COUNCIL ASSESSMENT REPORT TO PANEL

NORTHERN REGIONAL PLANNING PANEL

PANEL REFERENCE & DA NUMBER	PPSNTH-268 – Kempsey – DA2300926 – Phillip Drive, South West Rocks
PROPOSAL	Concept Development Application approval is sought for residential flat buildings, serviced apartments, shops and food and drink premises.
ADDRESS	Phillip Drive, South West Rocks
APPLICANT	Mr Daniel Pszczonka
OWNER	Rise South West Rocks Pty Ltd
DA LODGEMENT DATE	14 November 2023
APPLICATION TYPE	Development Application
REGIONALLY SIGNIFICANT CRITERIA	Capital Investment Value > \$30M
CIV	\$127,832,372.00 (excluding GST)
CLAUSE 4.6 REQUESTS	NIL
KEY SEPP/LEP	<ul style="list-style-type: none">• State Environmental Planning Policy (Housing) 2021• State Environmental Planning Policy (Biodiversity and Conservation) 2021• State Environmental Planning Policy (Planning Systems) 2021• State Environmental Planning Policy (Sustainable Buildings) 2022• State Environmental Planning Policy (Transport and Infrastructure)

SITE PLAN

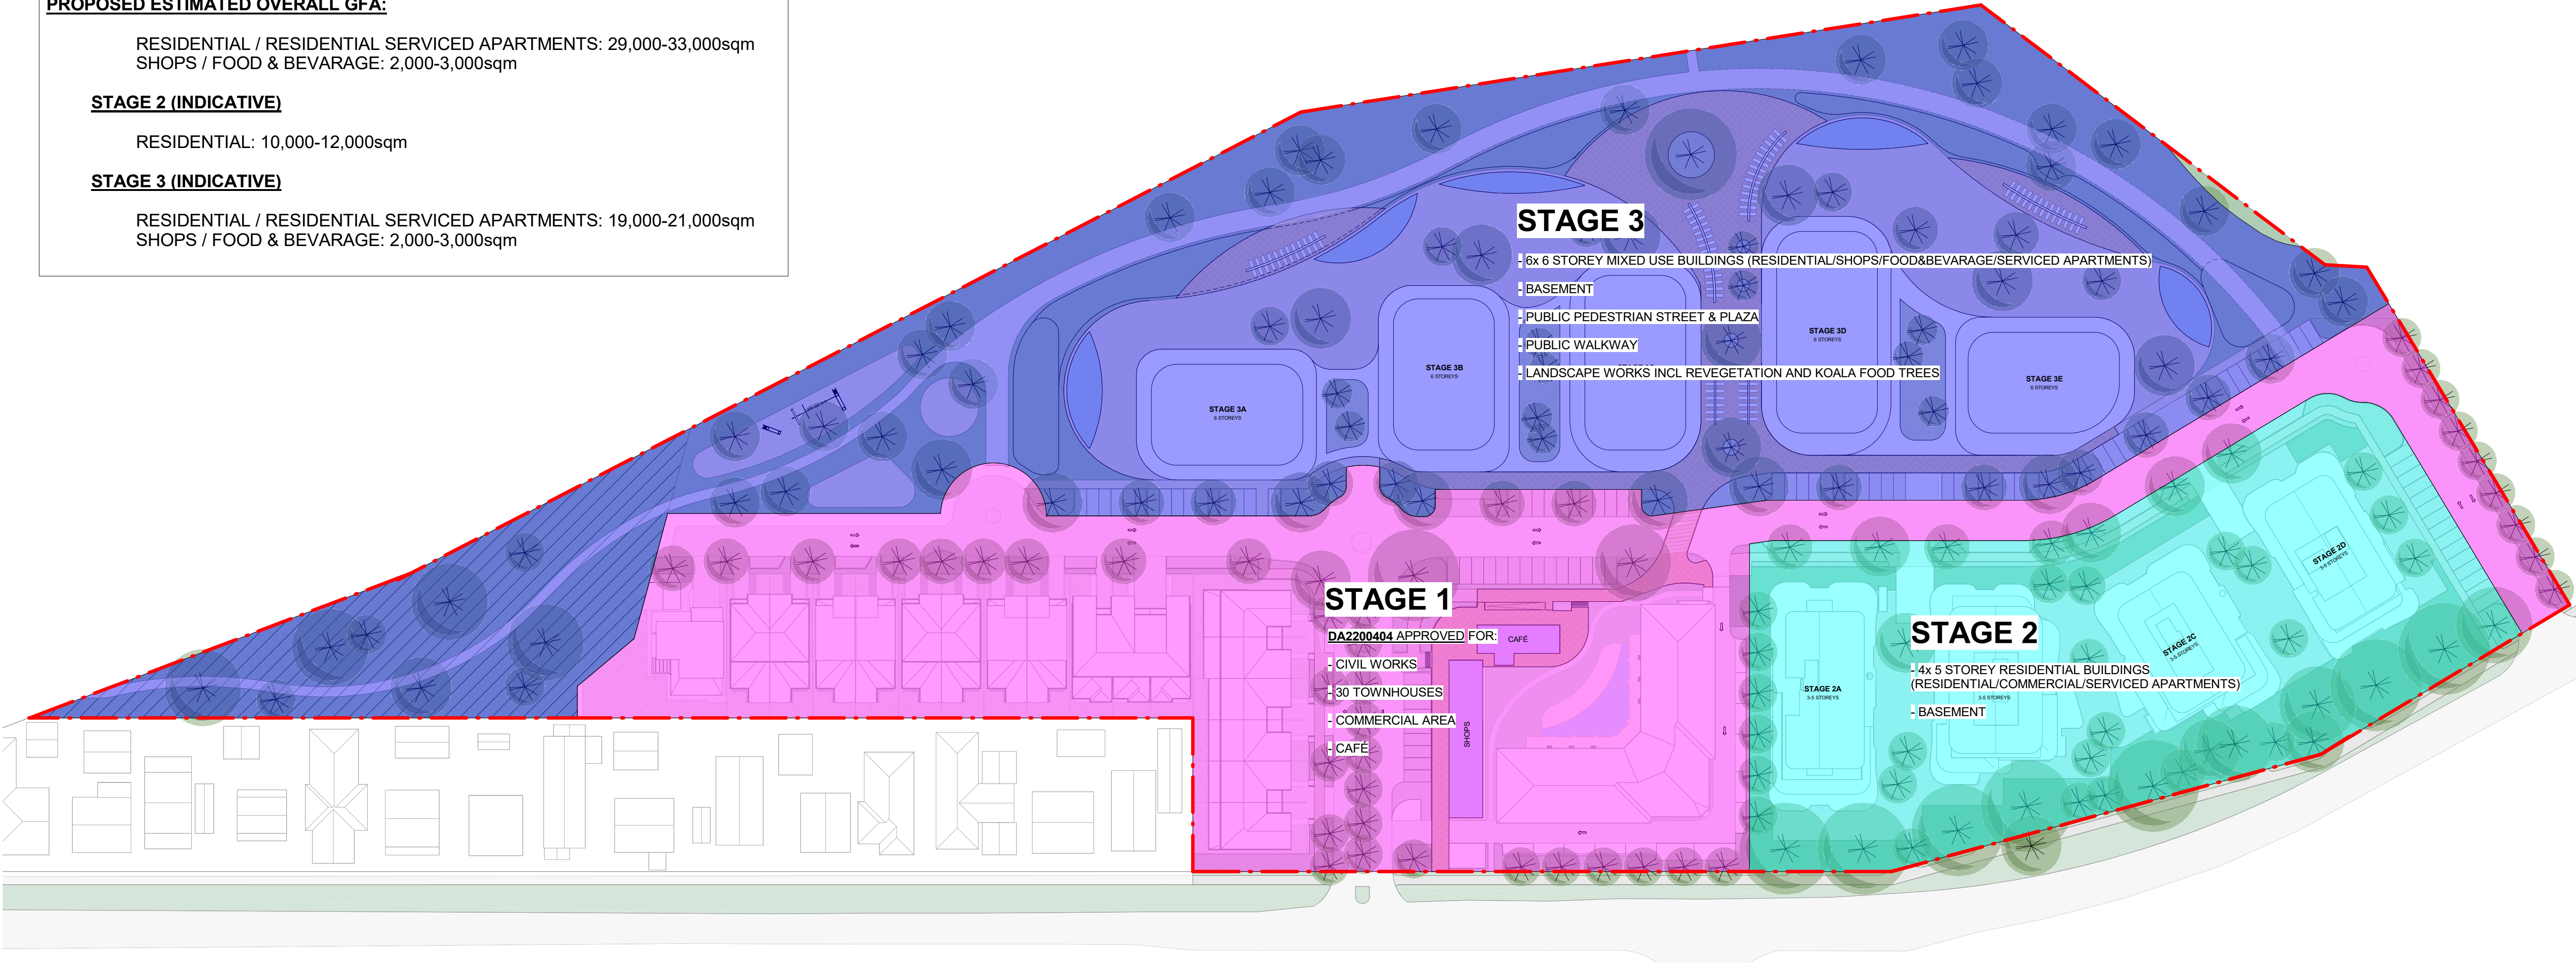
Agency	Comments	Resolved
<p>'located on Trial Bay Front Beach' (see, for example, https://www.riseprojects.com.au/projects/the-rocks/).</p> <p>With respect to the current proposal, we note Drawing No. DA-CST2&3-04.01 in the SEE's Appendix 3 (copied as Figure 6 in the SEE) identifies and labels the potential for this future access to the beach via connection to Fishos Trail. Several other drawings also indicate this future pathway.</p> <p>The current beach access points that should be promoted to future residents of the development include the established route along the boundary of the national park (230m west of the subject site and linked by a proposed track in Stage 3 that enters Crown land behind number 58 Phillip Drive) or the Fishos Trail entry pathway from Phillip Drive (500m to the east). NPWS confirms it is not supportive of creating additional access routes through the national park in this locality given alternative public access points nearby.</p> <p>The lands between the subject site and the national park include the southern riparian corridor of Saltwater Creek which is a mapped coastal wetland and is currently zoned C2 Environmental Conservation. It would be appropriate for this area to be fenced to aid in its protection from future encroachments, both during construction works and following the establishment of the subdivision.</p> <p>We consider the proposed 4-metre wide buffer identified in the site plan is insufficient to protect riparian values given the level of fill and earthworks proposed on the site during Stage 3.</p> <p>NPWS Recommendation</p> <p>4. Revision of drawings DA-CST2&3-05.02, DA-CST2&3-05.03, DA-CST2&3-05.04, DA-CST2&3-05.05, DA-CST2&3-05.06, DA-CST2&3-05.07, DA-CST2&3-04.01, DA-CST2&3-04.02, DA-CST3-01.01, DA-CST3-01.02 and DA-CST3-01.03 be undertaken to exclude mention or indication of a potential future access path leaving the subject site and its potential connection to Fishos Trail.</p>

Further, the Concept Development Application documentation supplied concerning mosquito management does not have regard to the location and functional operation of the proposed wet stormwater basin shown on the plan DA_CST 2&3-04.1 within the proposed mosquito buffer area.
